[Docket No. 2000-SW-51-AD; Amendment 39-11960; AD 2000-20-51]

**Airworthiness Directives; Robinson Helicopter Company Model R22 Helicopters**

**2000-20-51 Robinson Helicopter Company:**  
Amendment 39-11960. Docket No. 2000-SW-51-AD.

**Figure A**

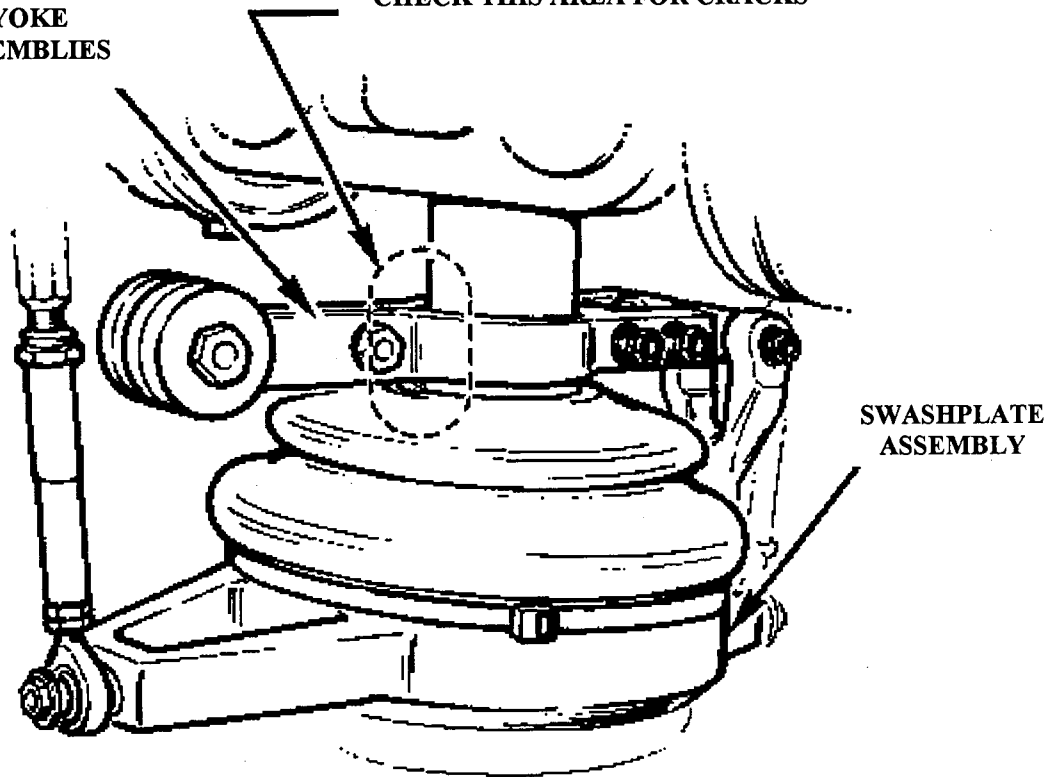
(a) Before further flight and thereafter before the first flight of each day, check each yoke for a crack. See Figure A.

**CHECK THIS AREA FOR CRACKS**

(b) If a yoke is cracked, before further flight, replace the yokes with airworthy yokes, P/N A203-7. Both yokes must be replaced with yokes, P/N A203-7.

(2) If the Lot identifier is from 24 through 43, if it is a letter code, or if it is illegible, replace yokes, P/N A203-5, with airworthy yokes, P/N A203-7. Yoke, P/N A203-7, cannot be installed with yoke, P/N A203-5.
